UNITED STATES PATENT AND TRADEMARK OFFICE

APPLICATION NO.	FILING DATE	FIRST NAMED INVENTOR	ATTORNEY DOCKET NO.	CONFIRMATION NO.
10/815,581	03/31/2004	Michael J. Antal JR.	UOHIP006D1	9383
22434	7590	08/09/2005	EXAMINER	
BEYER WEAVER & THOMAS LLP P.O. BOX 70250 OAKLAND, CA 94612-0250			NECKEL, ALEXA DOROSHENK	
			ART UNIT	PAPER NUMBER
			1764

Office Action Summary	Application No.	Applicant(s)	
	10/815,581	ANTAL, MICHAEL J.	
	Examiner Alexa D. Neckel	Art Unit 1764

DETAILED ACTION

Figure 2. Schematic of the laboratory reactor.

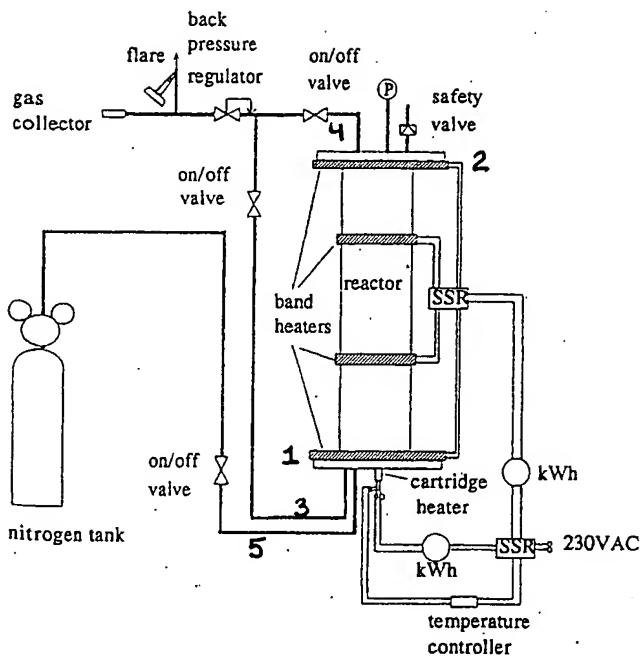
With respect to claim 20, Antal Jr. et al. discloses a reactor (figure 2) which comprises a housing (pressure vessel) with a sealable opening (pressure-tight hinged closure) for receiving a removable canister with a lid; heaters which heat the distal end (2) of the canister (fig. 2) (page 653, col. 2, paragraph under "Apparatus and Experimental Procedures"); a first valved exit orifice (3) at a proximal end (1) and a second valved exit (4) orifice at a distal end (2) of the housing (pressure vessel); and a valved entry orifice (5) at the proximal end (1) (page 653, col. 2, paragraph under "Apparatus and Experimental Procedures").

Figure 2 of Antal Jr. et al. does not provide reference numbers, so the examiner has numbered various elements below to provide further clarification of how the reference has been applied.

With respect to claim 22, Antal Jr. et al. further discloses wherein a flare (burner) is in communication with the second valved exit (4) (see figure 2).

With respect to claim 24, the schematic illustration of Antal Jr. et al. has been applied so that the proximal end (1) is at the bottom and the distal end (2) is at the top of the vertically arranged device shown in figure 2. The device of Antal Jr. et al. arranged so that the proximal end (1), and its associated elements, is at the top while the distal end (2), and its associated elements, is at the bottom of the vessel would still be the same apparatus (only turned on end). It appears from the description of the operation of Antal Jr. et al.'s device, that in such an orientation, the device would continue to be operational. It has been held that there is no invention in shifting the location of parts when the operation of the device would not thereby be modified. In re Japikse, 86 USPQ 70 (CCPA 1950).

The schematic of the apparatus of Antal Jr. et al (figure 2) only illustrates that the valved entry (5) passes into the proximal end (1) but fails to illustrate if it extends into the canister.
